Executive Director's Recommendation

PROJECT Rock Creek Park Trail Access and Safety Improvements Washington, DC	NCPC FILE NUMBER 7998
SUBMITTED BY United States Department of the Interior National Park Service	NCPC MAP FILE NUMBER 23.00(38.00)44894
REVIEW AUTHORITY Federal Projects in the District per 40 U.S.C. § 8722(b)(1) and (d)	APPLICANT'S REQUEST Approval of preliminary and final site development plans
	PROPOSED ACTION Approve preliminary and final site development plans with comments
	ACTION ITEM TYPE Open Session

Rock Creek Park Trail Access and Safety Improvements

Approval of Preliminary and Final Site Development Plans

Tree Removal/Replacement

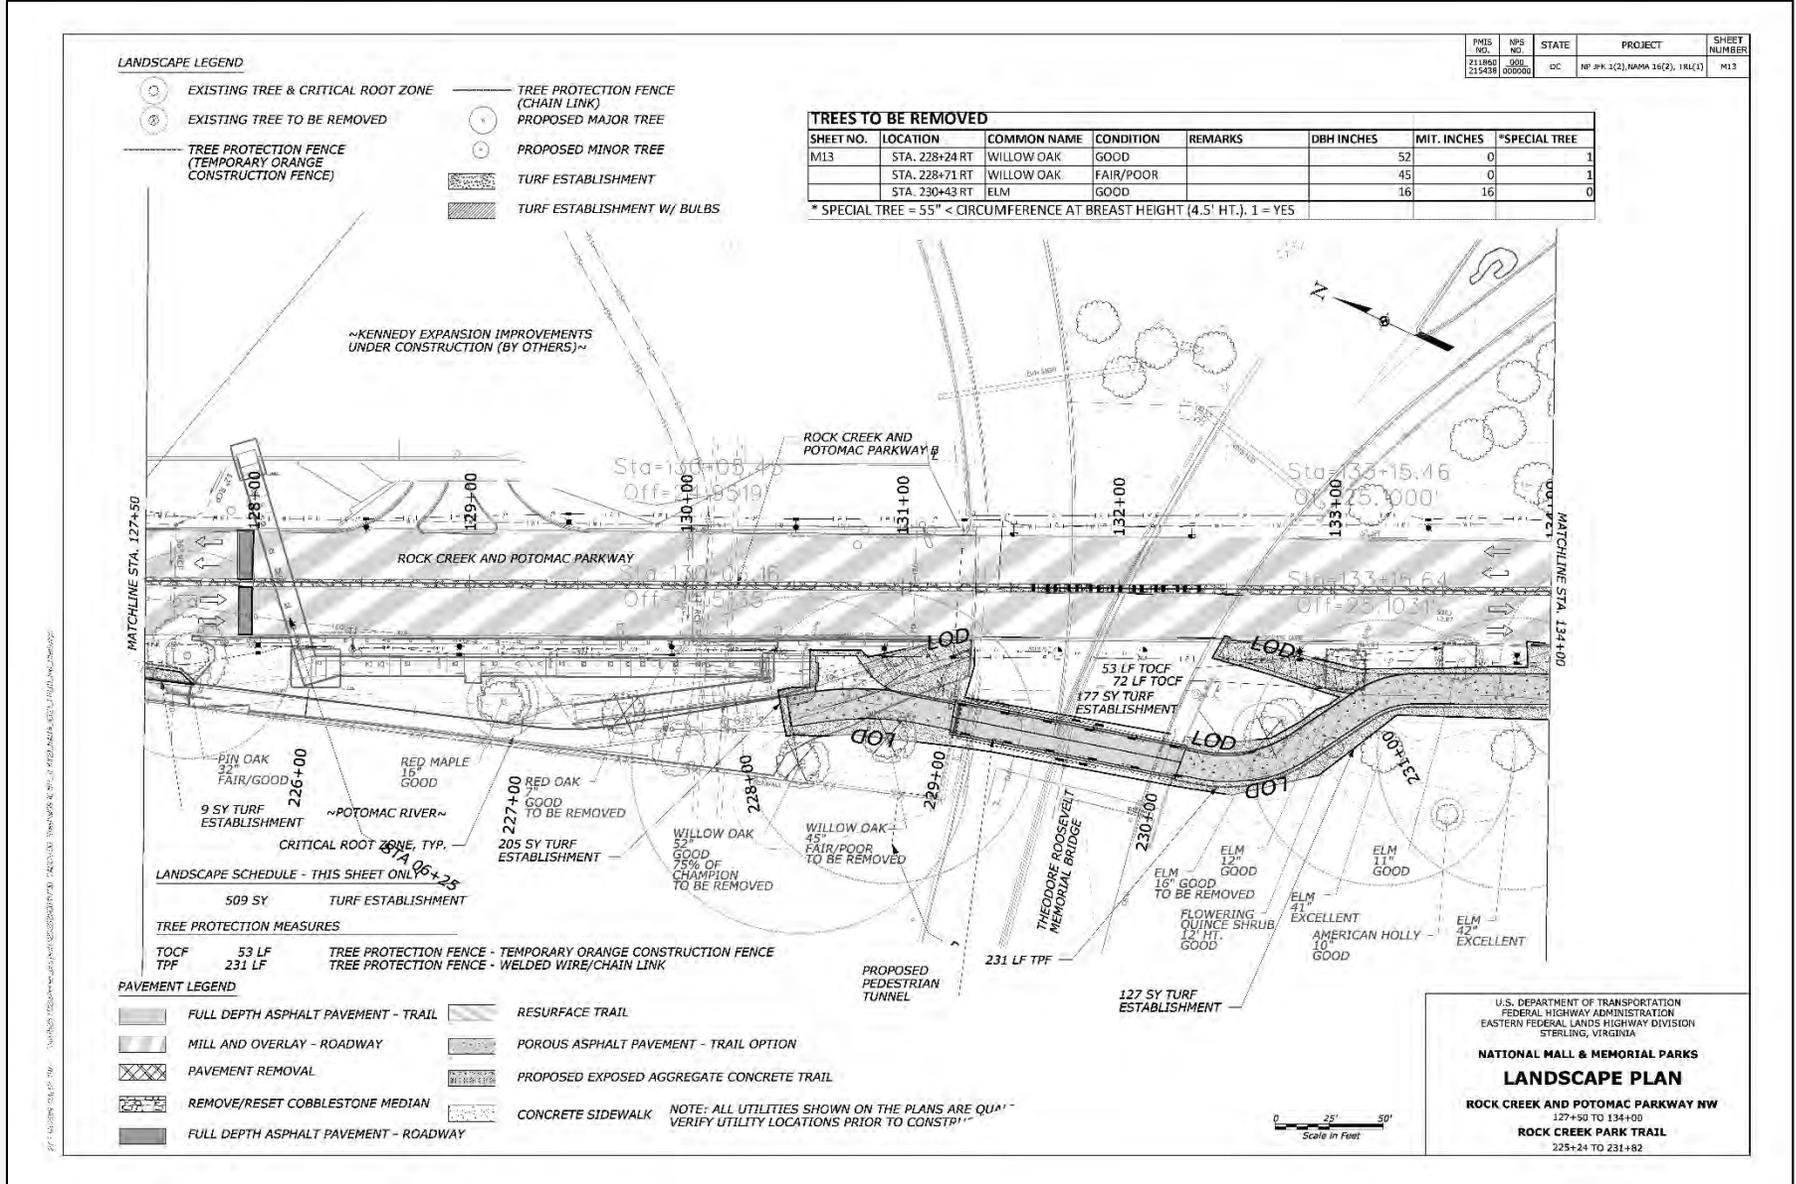
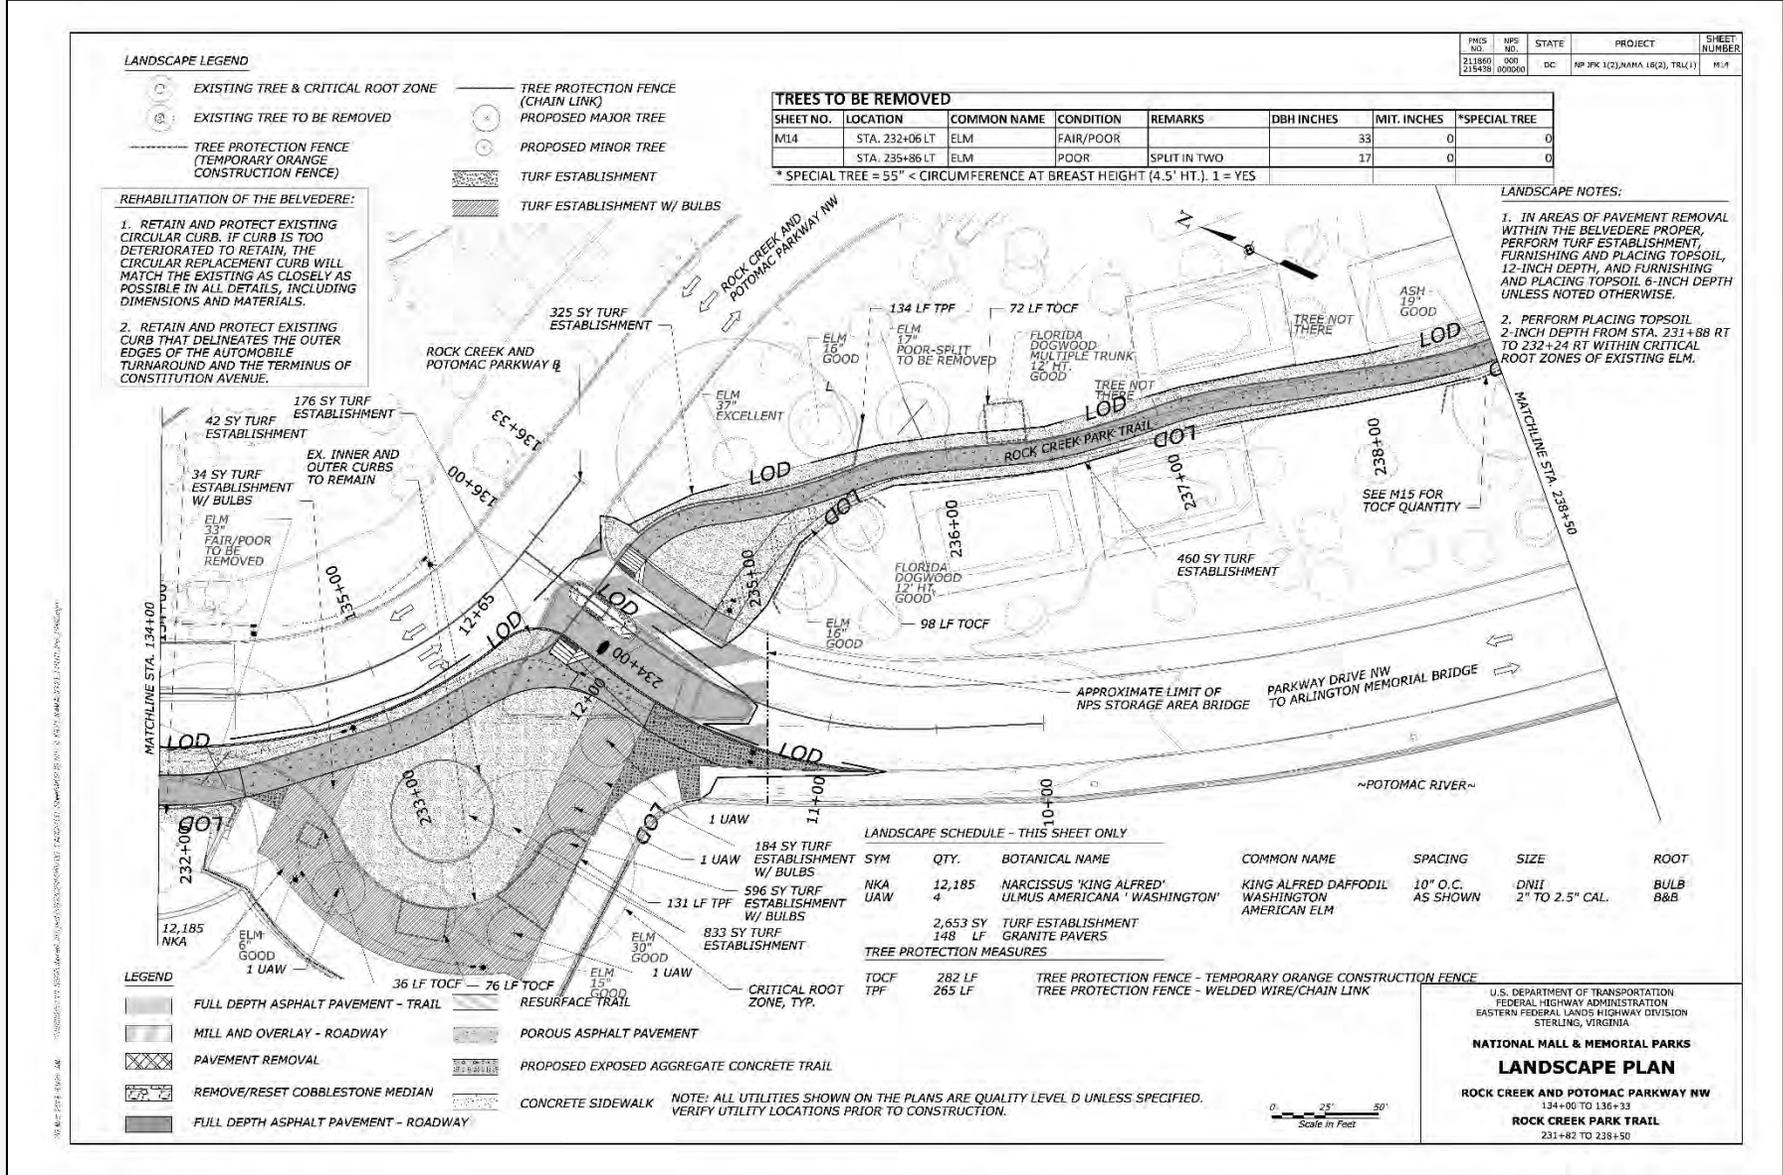
Notes that 13 trees will be removed as a result of the project, all of which are either in poor condition or directly impacted by the project construction. Guidance in the cultural landscape report for the site limit the number of trees that can be planted, so the project will still result in a

net loss of tree canopy, though all trees will be replaced with two-inch to two-and-a-half-inch caliper trees at a one-to-one ratio.

In response to Commission comments on the concept design, the applicant has provided more information on tree removal and replacement that would occur as a result of the trail widening. The applicant has indicated that 13 trees will be removed as a result of the project, all of which are either in poor condition or directly impacted by the project construction, and that all trees would be replaced with 2- to 2.5-caliper trees at a one-to-one ratio in accordance with the cultural landscape report for the site. Because many of the trees are larger and more mature, the replacement trees will not fully mitigate the loss of tree canopy. Despite the net loss of tree canopy, staff believes that the tree replacement strategy effectively balances preservation of the historic landscape with natural resource considerations.

Renderings - Belvedere

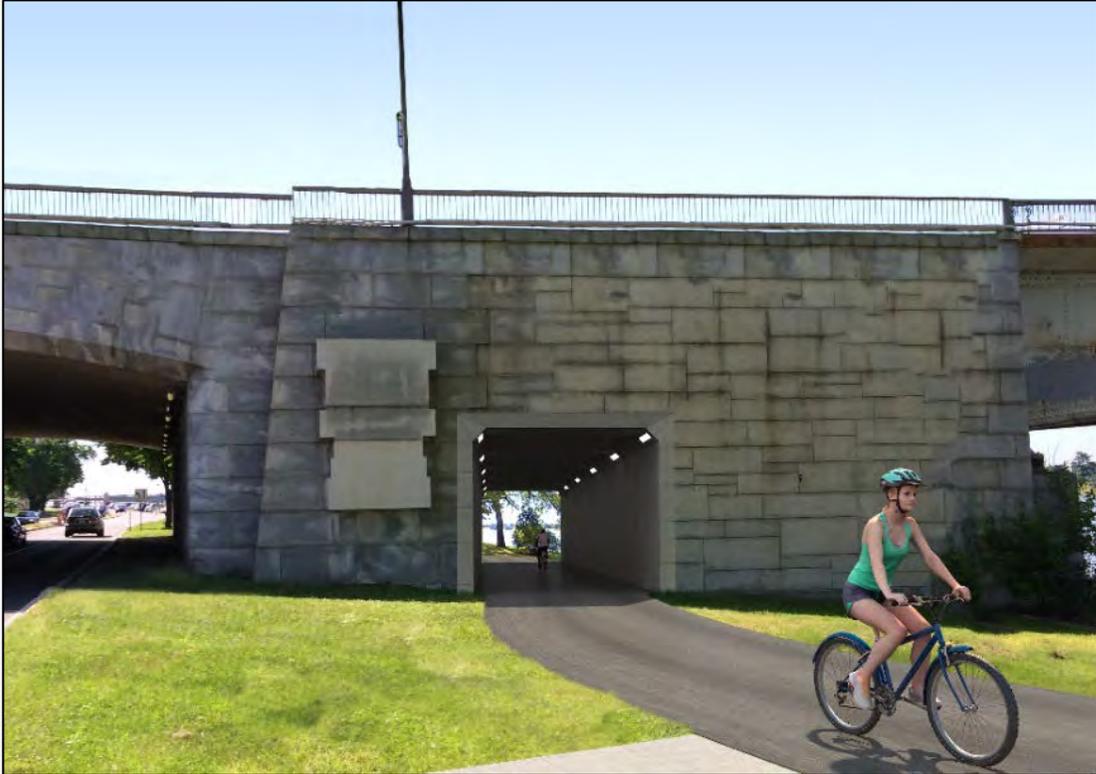
The concept design had indicated that the footprint of the original turnaround would be retained, slightly mounded, and planted with daffodils. This revised submission still retains the turnaround

footprint, but a green lawn will be planted instead of the daffodils. To ensure the integrity of the historic landscape, the applicant will retain the circular granite curb to indicate the location of the original turnaround and will add a curb that delineates the outer edges of the automobile turnaround and the terminus of Constitution Avenue. Consistent with the concept design, plantings are also proposed along the existing pathway along the river, and several new trees are proposed in the area to create a bosque that defines the termination of old Constitution Avenue, NW, corridor. Staff believes that the proposed improvements will greatly improve safety and navigation for pedestrians and bicycles in this location while creating a parklike setting that is more appropriate for commemoration and contemplation, which would support its potential future use as a memorial site.
